Town Planning Submission

SSD-84348959 – 19 Hope Street, Melrose Park 2114 and 69, 71, 73, 75, 77 Hughes Avenue, Ermington 2115 NSW 2115

State Significant Development Application– Mixed development within four towers containing ground floor retail, 197 affordable housing units and 154 co-living units.

Figure 2 – Indicative Melrose Park Gateway Site Development Scheme and Built Form (Source: Gateway determination report October 2023)

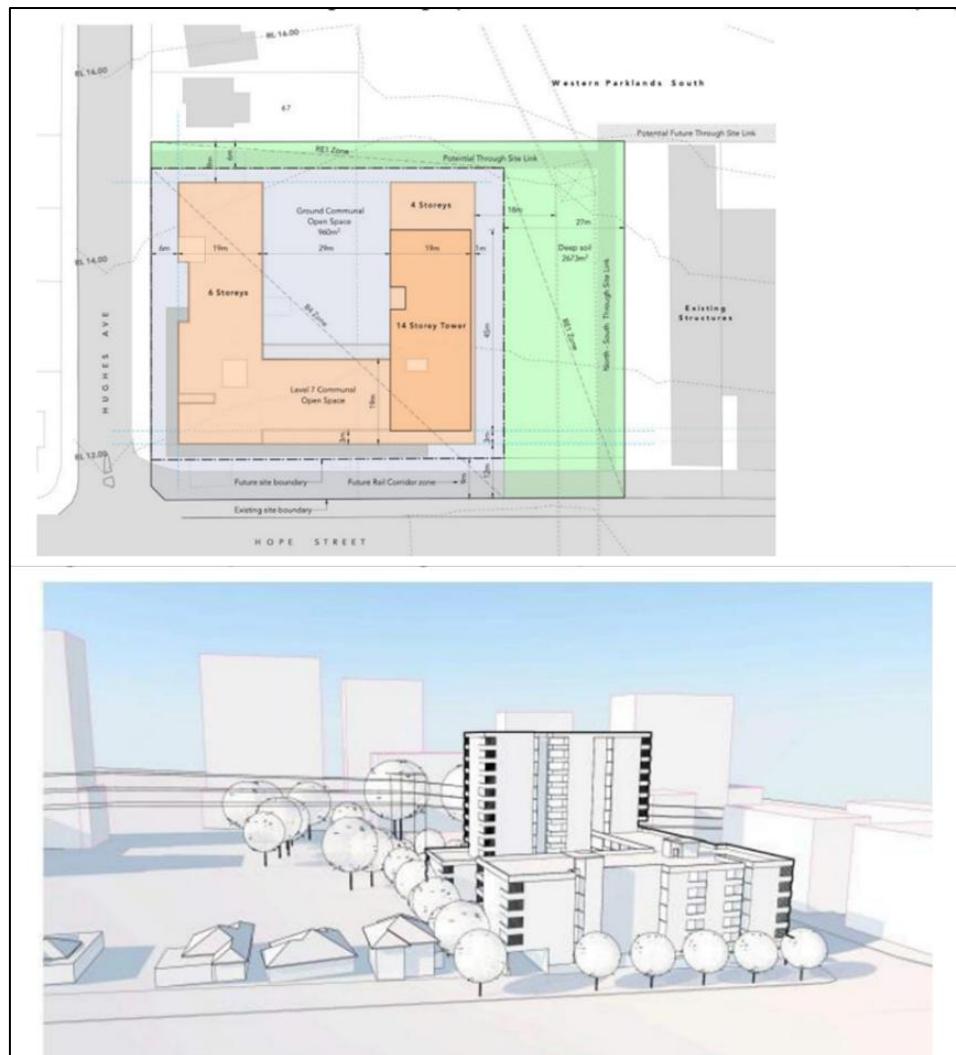
The SSDA is accompanied by a concurrent Planning Proposal that seeks to amend the existing planning controls to the Parramatta LEP 2023 (PLEP 2023). The proposed amendments include increases to the maximum building height and floor space ratio (FSR), and a reduction in the required non-residential floor space, as summarised in the table below. The proposal represents an increase of approximately 190 dwellings (see **Fig 2 & 3**) compared to the yield contemplated under the previously adopted PP controls.

While the commitment to affordable housing outcomes is recognised, the extent of the uplift sought comprising an increase in FSR from 2.67:1 to 3.75:1 and height from 48m to 64m must be considered with respect to the broader capacity of the precinct to cater for the uplift and the significant reliance on public transport infrastructure. Noting the adoption of significantly reduced car parking rates for the affordable / co-living housing (122 spaces for 351 apartments).

The SSDA should not be approved until there is an integrated strategic land use and transport review undertaken by Government to determine whether the number of dwellings is appropriate and consistent with supporting and promoting the economic redevelopment of the entire Melrose Park Precinct.

Figure 4 – Construction vehicle routes Source: Melrose Part Gateway TIA, JMT Consulting)

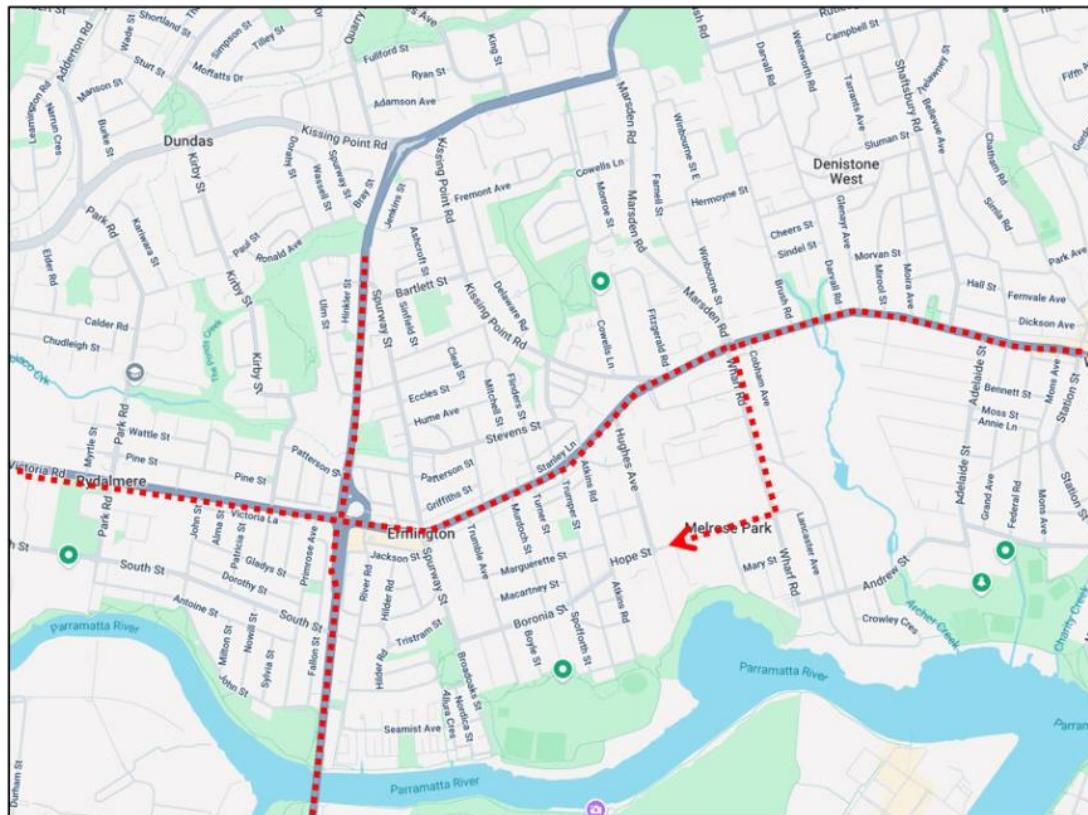
The Transport Impact Assessment (TIA) identifies Hope Street via Wharf Road as the primary access route for all construction traffic, with all heavy vehicles proposed to enter and exit via this road. Given the construction site is immediately adjacent the GWF facility this is a significant concern.

A Construction Traffic Management Plan (CTMP) has not been prepared, nor is there sufficient preliminary construction staging or strategy in the TIA. Without a CTMP, the EIS fails to demonstrate how construction access will be managed, how construction routes will avoid conflict with ongoing GWF operations, or how staging will mitigate impacts on the constrained Hughes Avenue / Hope Street corridor. The failure to properly consider construction traffic impacts at this stage is a significant omission in the traffic and transport assessment.

- No on street queuing for construction vehicles be allowed. All queuing should occur on the internal roads within the construction site;
- Provision should be made for parking within the construction sites or within the Melrose Park North Precinct to limit the likelihood of on-street parking; and
- A wider CTMP be prepared that accounts for all surrounding construction works (Melrose Park north and south) and that identifies actions to ensure the impact on the operation of the bakery are minimised. In considering the potential impact on the bakery plant, this wider construction management plan should be prepared and forwarded to GWF as part of the SSDA assessment.

Figure 6– Shadow Diagrams, June 21, 11am-12pm, GWF Site approximate outlined in Red (Source: SSDA - Architectural Drawings, TURNER, July 2025)

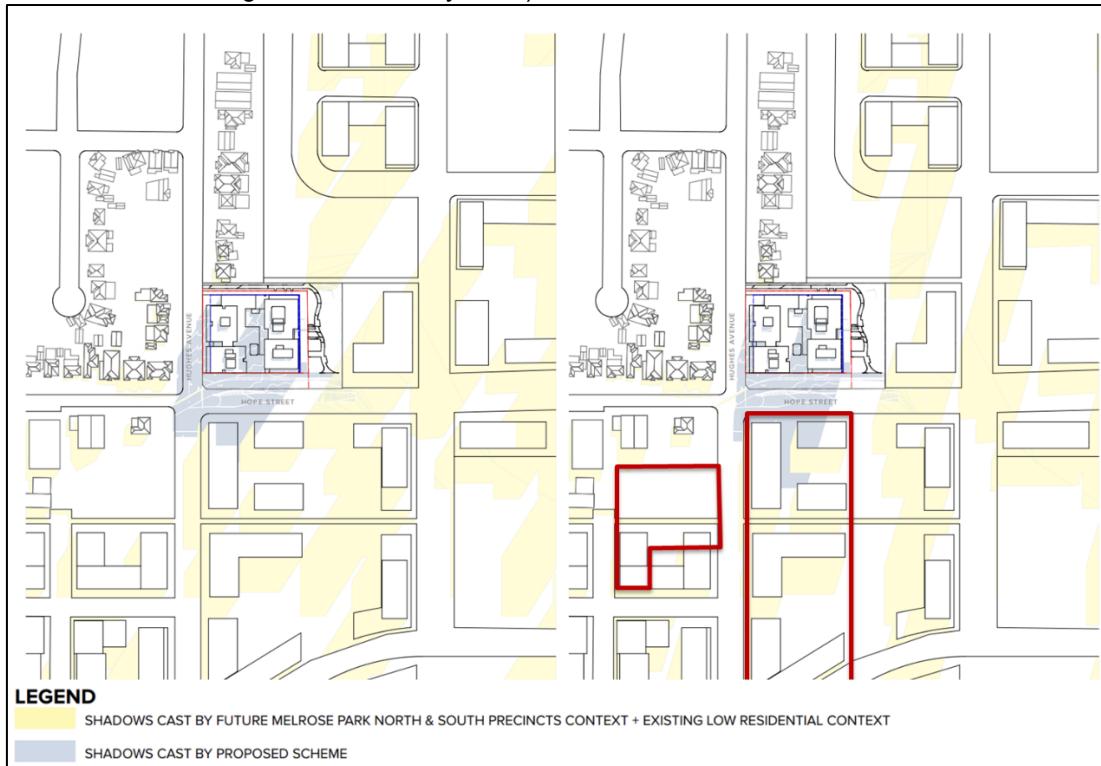
The architectural drawings accompanying the EIS include shadow diagrams which distinguish between shadows cast by future development within the Melrose Park North and South precinct, and shadows cast by the proposed development itself. While the design report asserts that building heights and orientations have been carefully planned to respect neighbouring streets and properties, the shadow diagrams nevertheless detail that there will be substantial overshadowing of the GWF site.

The shadow diagrams prepared indicate that the GWF site will be significantly affected with respect to overshadowing generated by the proposed development and as part of the development of the broader precinct. The shadow diagrams indicate that overshadowing of the northern part of the site will occur between the hours of 10am – 3:30pm (see **Fig 5-8**) as measured on the winter solstice.

A revised solar access and overshadowing study is required to address the significant gaps in the analysis. This study should:

- Consider the impacts of a compliant development under the current maximum height of building and floor space ratio development standard;
- Provide a more detailed site-specific analysis on our client's land with consideration of the future development outcomes contemplated by the structure planning as a baseline;
- Provide clarity with respect to how overshadowing from the broader precinct has been considered as the shadow diagrams are not clear in terms of the assumptions and the distinction between individual sites;
- Provide sun eye diagrams which demonstrate how the proposal will impact upon future development on our client's land; and
- Give consideration to mitigation measures, such as upper level setbacks, increased tower separation, etc. to maintain equitable solar access to the GWF and public domain.
